TECHNICAL SERVICE BULLETIN

Bulletin Number: V-06-04
Model Years: 2004 & 2005

SUBJECT: Shift Lever Shaft Weld Failure

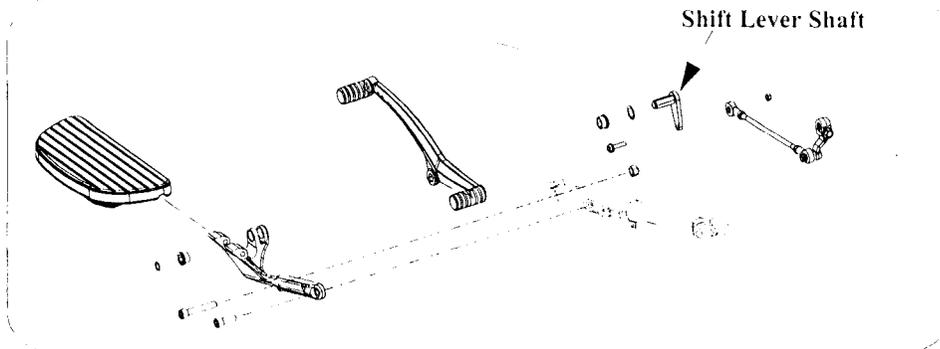
The welded joint on the shift lever shaft may fail, causing the shift pedal to become inoperable. The inability of an operator to shift gears increases the risk of a crash.

1. Contact owners of delivered units immediately and make arrangements to perform this warranty repair.
2. Replace the shift shaft lever shaft on all affected vehicles in your inventory following procedure outlined on page 3. DO NOT operate or sell an affected vehicle until this bulletin has been completed.
3. File a warranty claim for affected units immediately after completion of this bulletin. Follow warranty claim filing procedures on page 2.
